United States Patent and Trademark Office

APPLICATION NO.	FILING DATE	FIRST NAMED INVENTOR	ATTORNEY DOCKET NO.	CONFIRMATION NO.	
	10/670,566	09/26/2003	Osamu Kanome	01272.020632	2327	
	5514	5514 7590 12/15/2004		EXAMINER		
	FITZPATR	FITZPATRICK CELLA HARPER & SCINTO			FERGUSON, MARISSA L	
	30 ROCKEFELLER PLAZA NEW YORK, NY 10112			ART UNIT	PAPER NUMBER	
			2854

Application No.	Applicant(s)					
	10/670,566	KANOME ET AL.					
Office Action Summary	Examiner	Art Unit					
	Marissa L Ferguson	2854					
	The MAILING DATE of this communication appears on the cover sheet with the correspondence address						
Period for Reply							
A SHORTENED STATUTORY PERIOD FOR REPLY IS SET TO EXPIRE 3 MONTH(S) FROM THE MAILING DATE OF THIS COMMUNICATION. - Extensions of time may be available under the provisions of 37 CFR 1.136(a). In no event, however, may a reply be timely filed after SIX (6) MONTHS from the mailing date of this communication. - If the period for reply specified above is less than thirty (30) days, a reply within the statutory minimum of thirty (30) days will be considered timely. - If NO period for reply is specified above, the maximum statutory period will apply and will expire

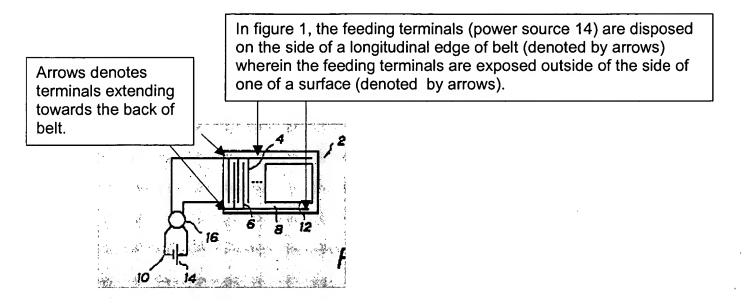
Claim 22 is rejected under 35 U.S.C. 102(b) as being anticipated by Kasahara (US 4,864,461).

Kasahara teaches an insulating layer (22), a plurality of electrodes arranged alternately with positive and negative with respect to an insulating layer (4,6 and Figure 2) and a plurality of feeding terminals each of the feeding terminals connected with each of the electrodes and disposed on the side of one of longitudinal edges of a belt, wherein feeding terminals for feeding positive voltage exposed outside of the side of one of a surface or a back of a belt and feeding terminals for feeding negative voltage extending towards the other of a surface or a back of a belt (Column 6, Lines 46-57 and Figures 1,3,4).

(Please refer to figure 1 below for further clarification)
